KENNEBUNKPORT ZONING BOARD OF APPEALS
Administrative Appeal Application

Addendum to Appeal to ZBA

This Appeal is filed on behalf of Randy Slager. The decision appealed from is the CEO's December 3, 2019 action lifting the prior CEO's July 17, 2019 suspension order on Ms. Bell's building permit #18-418, and land use permit #18-419, as shown in his e-mail to Lori Bell (copy attached as Exhibit 'A'.)

Subject: Response to Price Structural Engineers February 19, 2020 letter regarding
Rubble Retaining Walls and Stone Veneer/Reinforced Masonry Retaining Walls
200 Ocean Avenue, Kennebunkport, ME

Wall Section A11,
west side, Hole 1

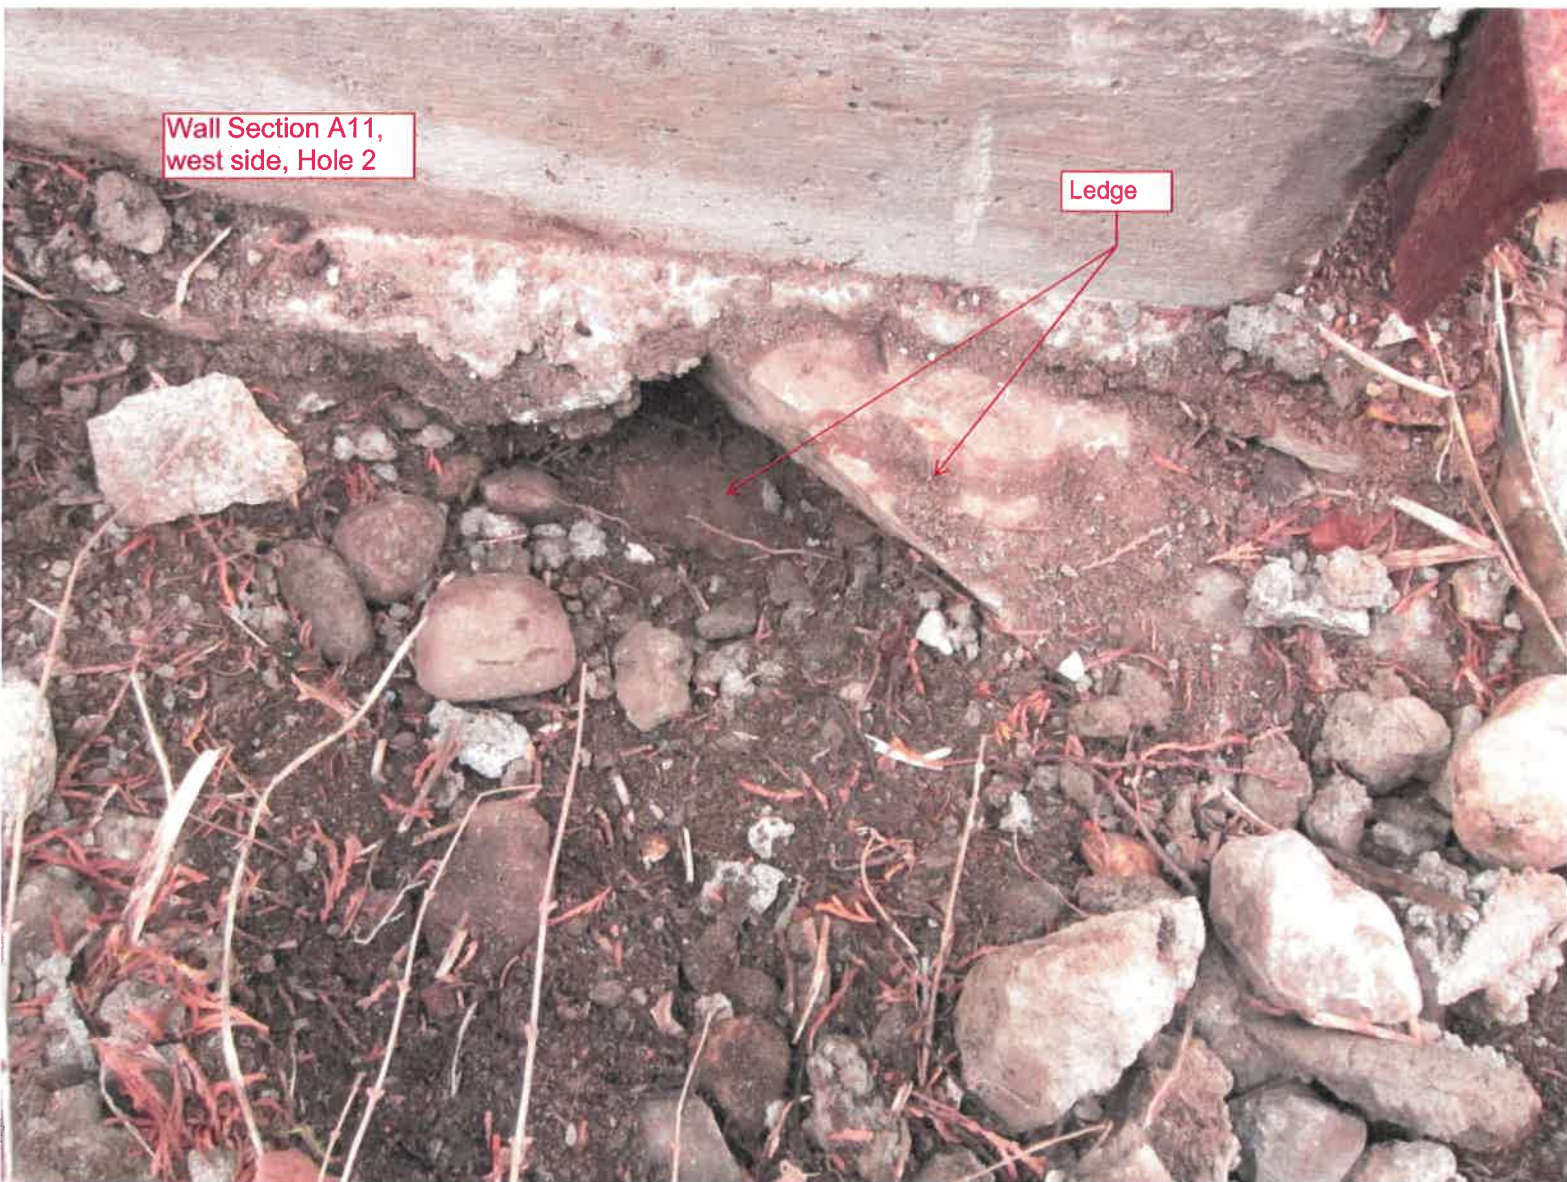
When additional information is gathered, PSE seeks to discredit facts which they do not suit PSE’s conclusions. Three test holes were dug on 2/5/2020 and found ledge below the CMU wall footing, as documented in our 2/5/2020 letter. Despite the new test holes, past photos, testimony by the builder, knowledge of the site from former and current owners, somehow PSE is alone in the belief that the wall does not bear on ledge. PSE tries to discredit plausible explanations regarding the findings of their probes, saying on page 9, “The Bell team is proposing that all of the A11 footings are bearing on ledge and that the edge of the ledge, perhaps somehow by amazing good luck and coincidence, just happens to align perfectly with the existing property line. On its face, this does appear to be suspiciously very convenient. The Bell team is further stating that they have no problem believing that the ledge is essentially at the top of the existing grade or close to it all along the property line but that just 17” to the west the ledge immediately drops off to more than 27” below top of grade.” Perhaps PSE is unaware that owners regularly adjust the elevation of ledge on their property, while not touching the rock on adjacent properties. Ledge removal is expensive, so owners remove as little ledge as possible to suit their goals. PSE may also be unaware that elevation of ledge can rapidly naturally change in Maine. Both common facts easily explain how ledge can vary over a short distance. Please also note – depth to ledge was about 8 to 10 inches below the grade at one of the test holes we dug, and 12 to 14 inches at another. Ledge would have to drop only 17 to 10 inches away from the wall to be lower than PSE’s probes. Wall A11 is founded on ledge, and so is not susceptible to frost heaves.
